CONSTRUCTION SERVICES FOR ENGINE HOUSE NO. 8 RENOVATIONS AND
UPGRADES

Solicitation Number: DCAM-19-CS-IFB-0012

Addendum No. 4

Issued: June 21, 2019

ELEVATIONS

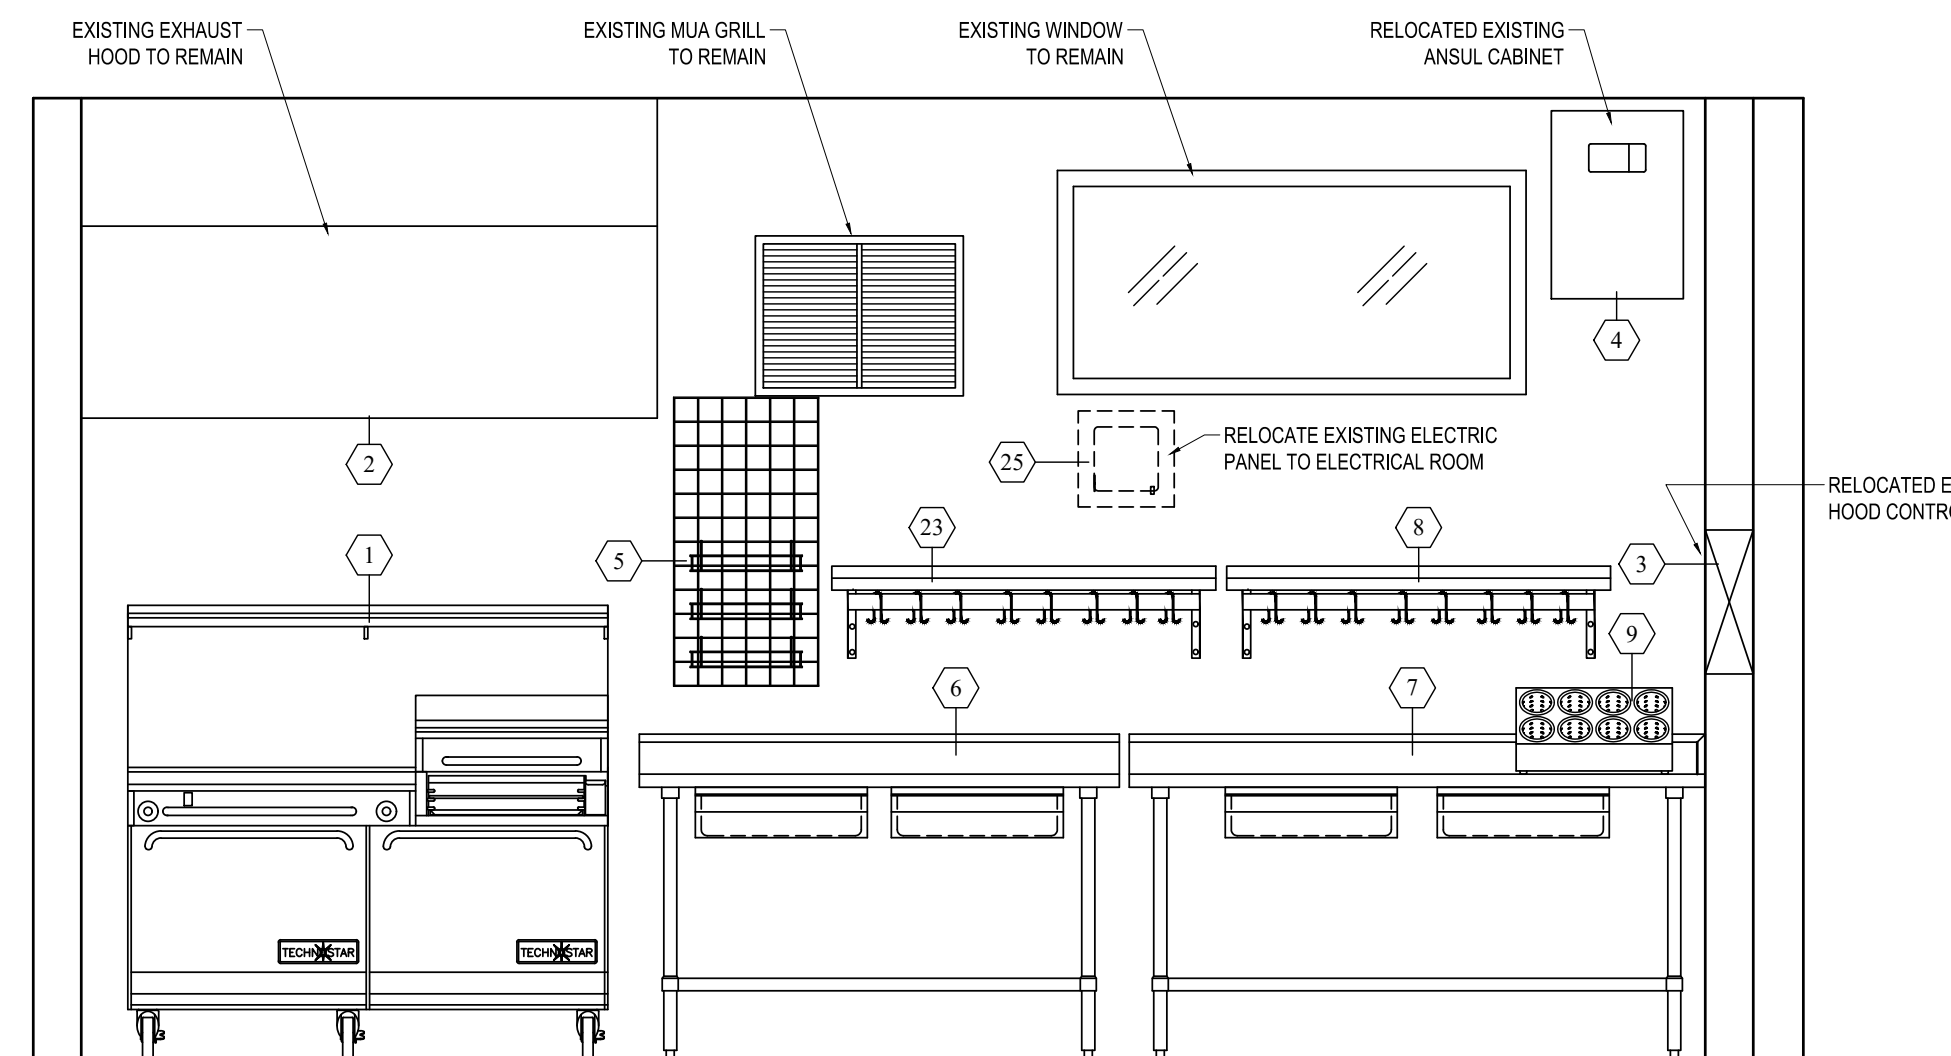
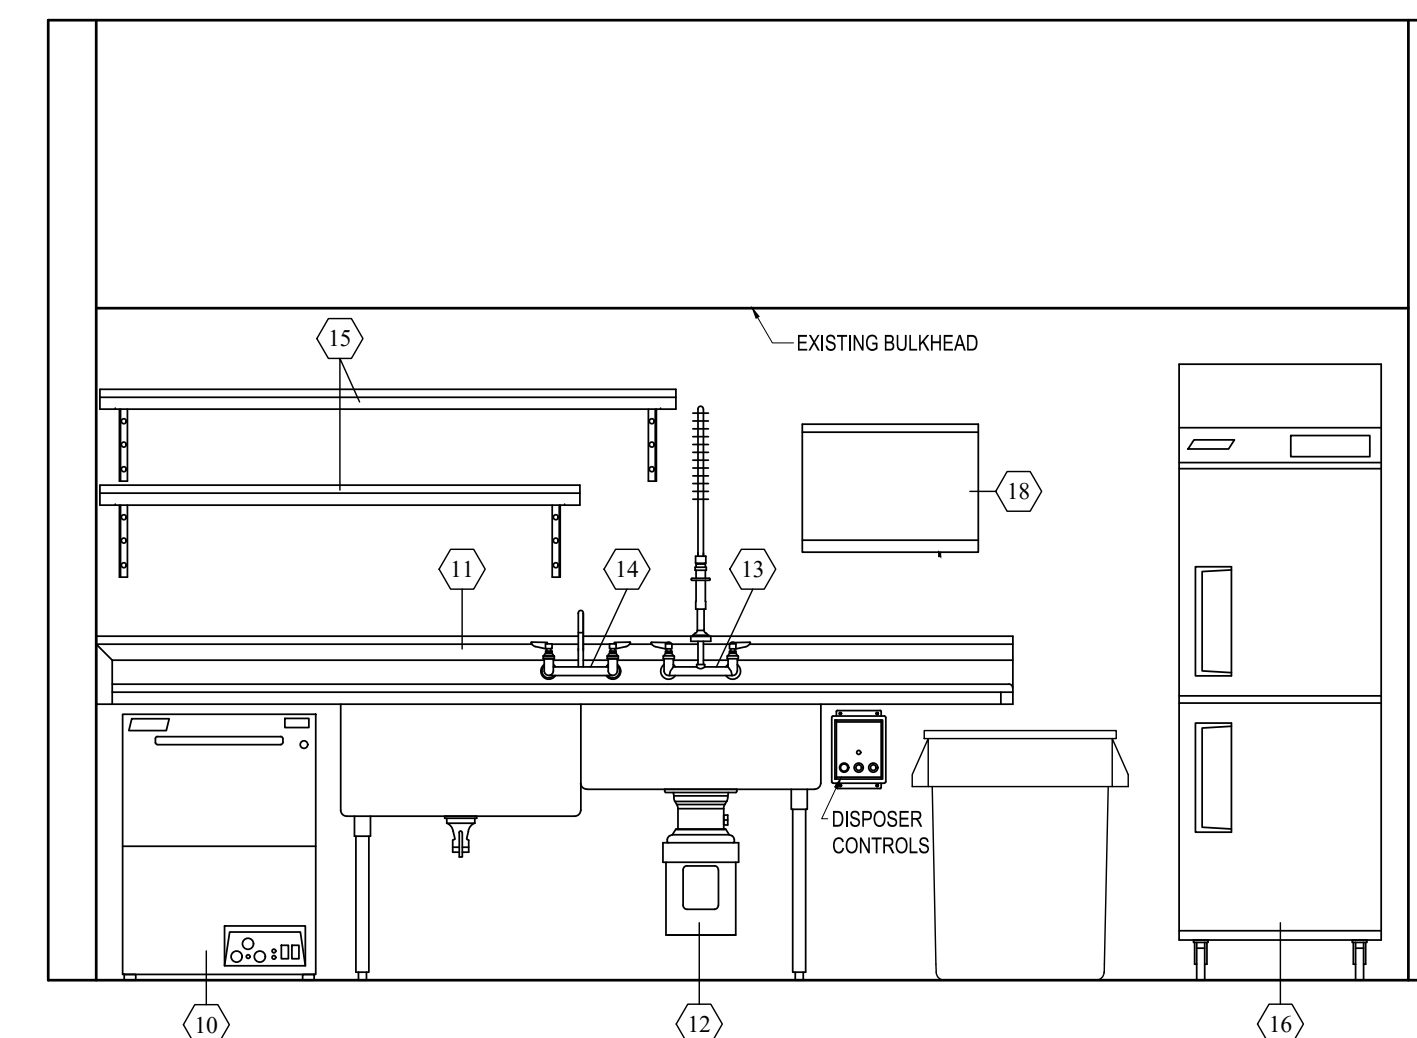
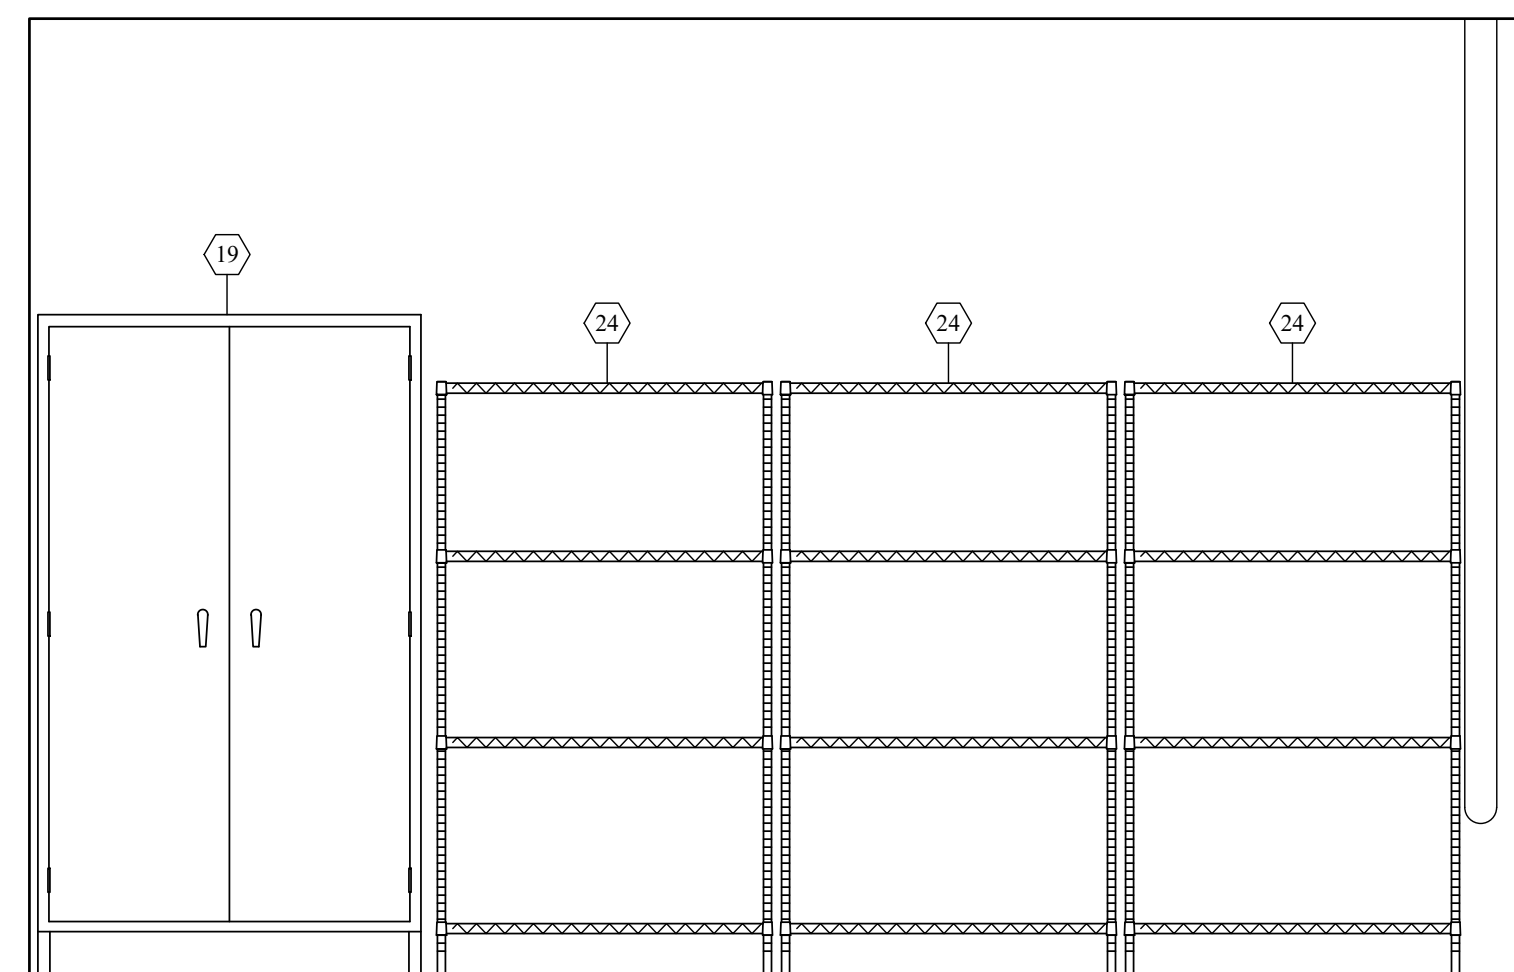
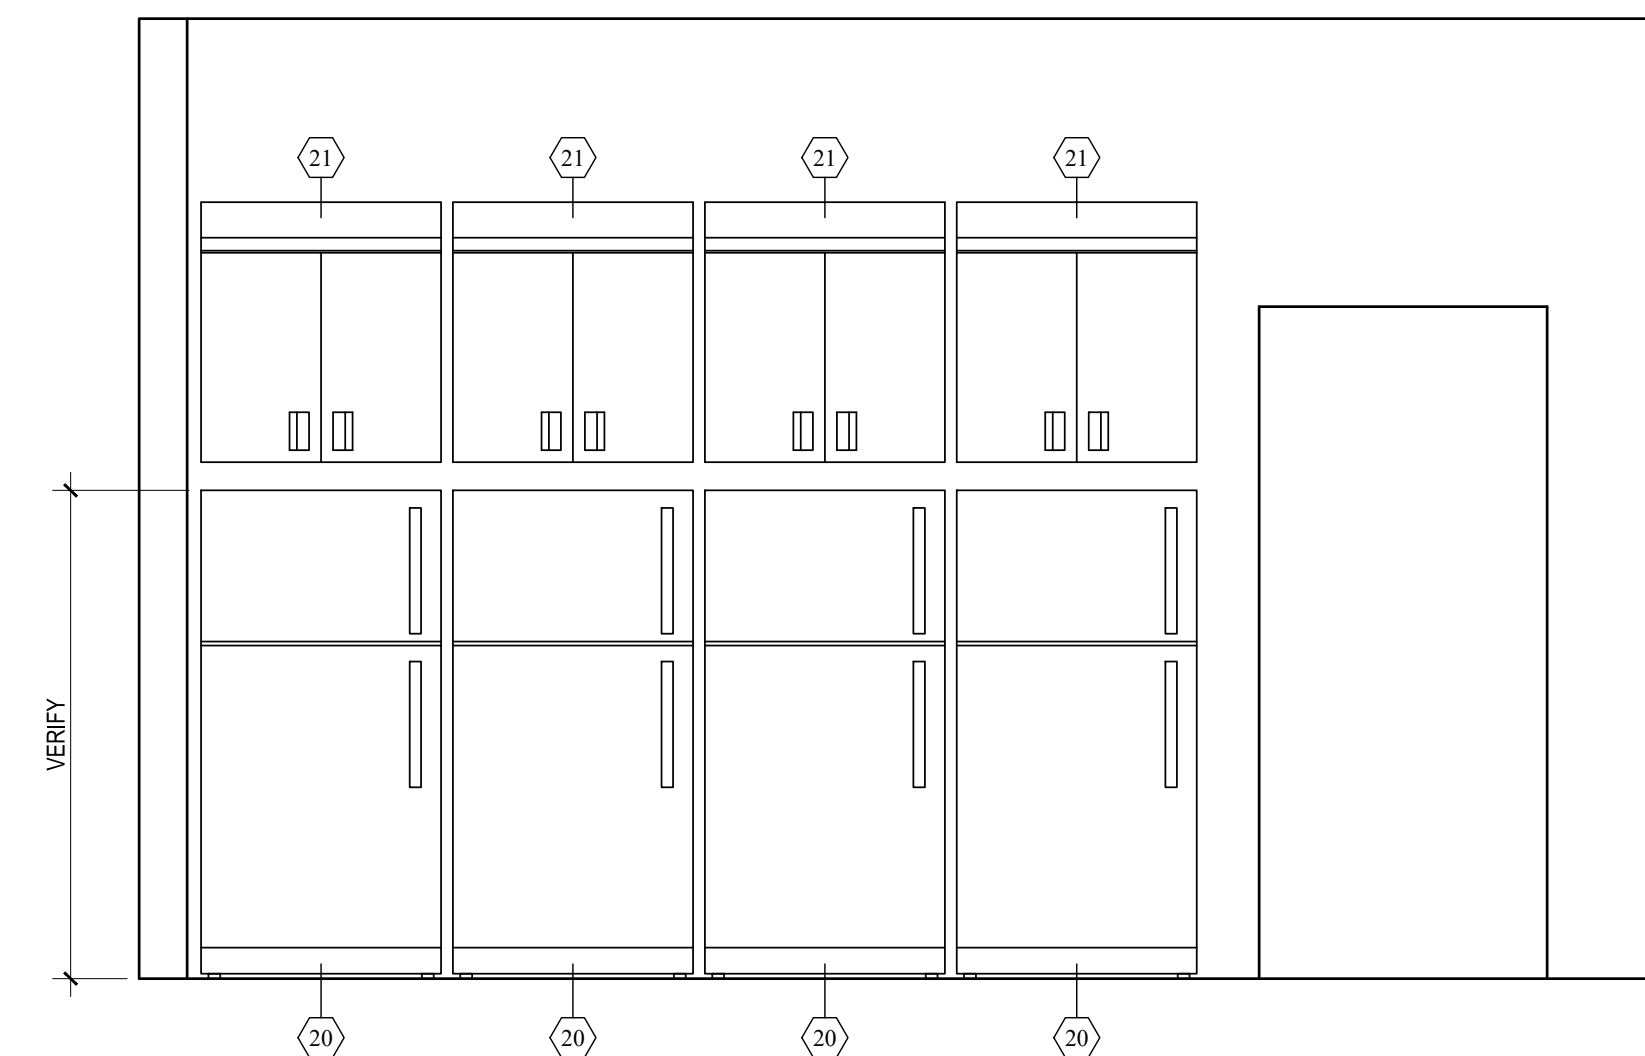
REVISIONS:
06/13/2019 EXISTING WINDOW & MUA GRILL TO REMAIN. RELOCATE EXISTING ELECTRICAL PANEL, HOOD CONTROL PANEL & ANSUL CABINET

MEN & WOMEN LOCKER ROOM FLOOR PLANS

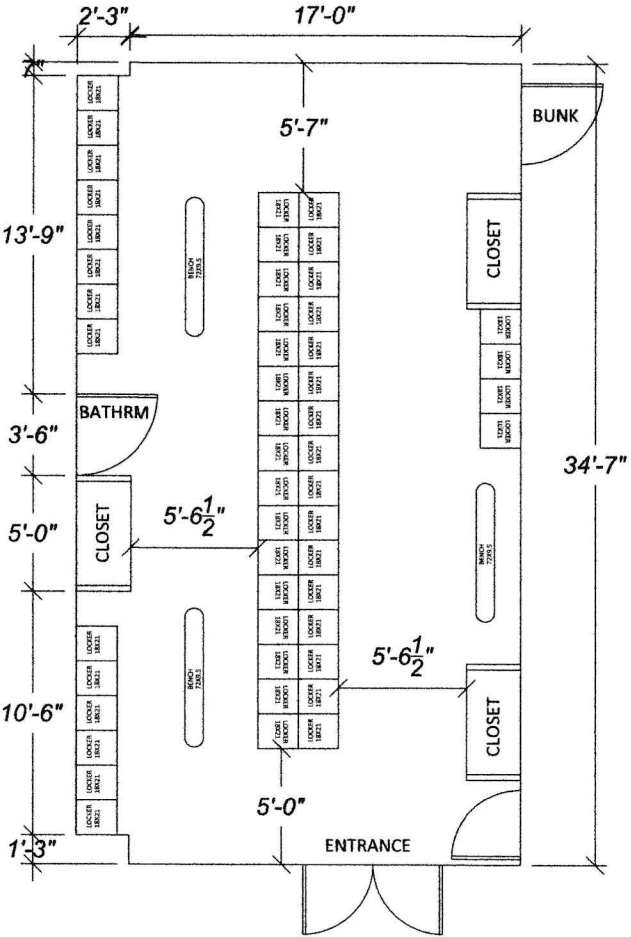
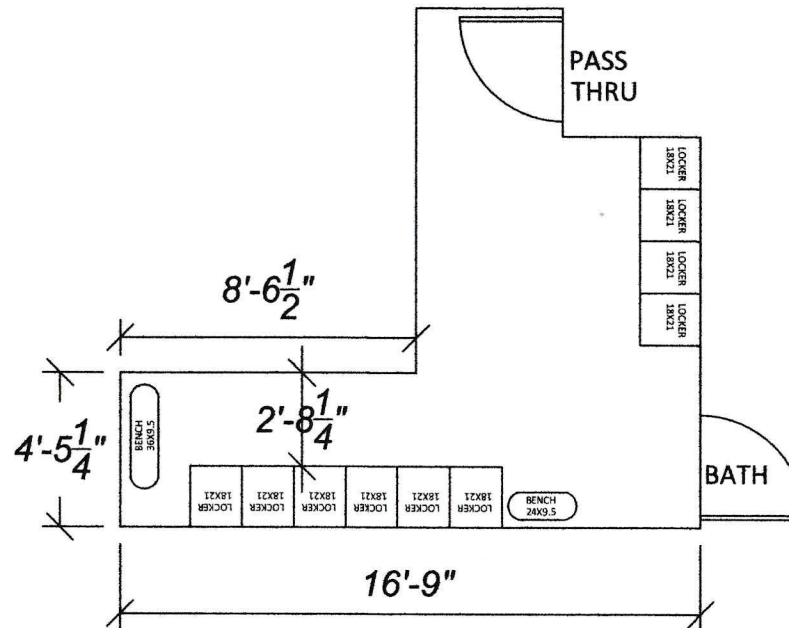
<p>to SWR Item O. Item O indicates new doors, frames, and hardware if new doors are required. Please confirm if the correct reference should be para (p) as it relates to access control (card reader).</p> <ul style="list-style-type: none"> • Upon reviewing the WH Hamilton drawing for Women’s Locker Room, the entry door swings in a different direction. Please confirm that we should reverse the existing door or replace the entry door opening with new 32”W hollow metal door, frame, and hardware in our bid. <p>g. The paragraph under Door Replacement section indicates to “replace all existing hardware in kind and per FEMS standards.” Our comment is two-fold:</p> <ul style="list-style-type: none"> • What are the FEMS standards? Please submit documents. • No door hardware schedule is provided over than closures, silencers and kickplates using Best Hardware per para. (o) in SWR. We may use allowance for new hardware in our bid. <p>h. All new exterior and bay doors should be priced as follows:</p>	<p>g. Refer to J.1 points O and P.</p> <p>h. No allowances to be accepted. Hardware to be replaced in kind as stated per the SWR</p>
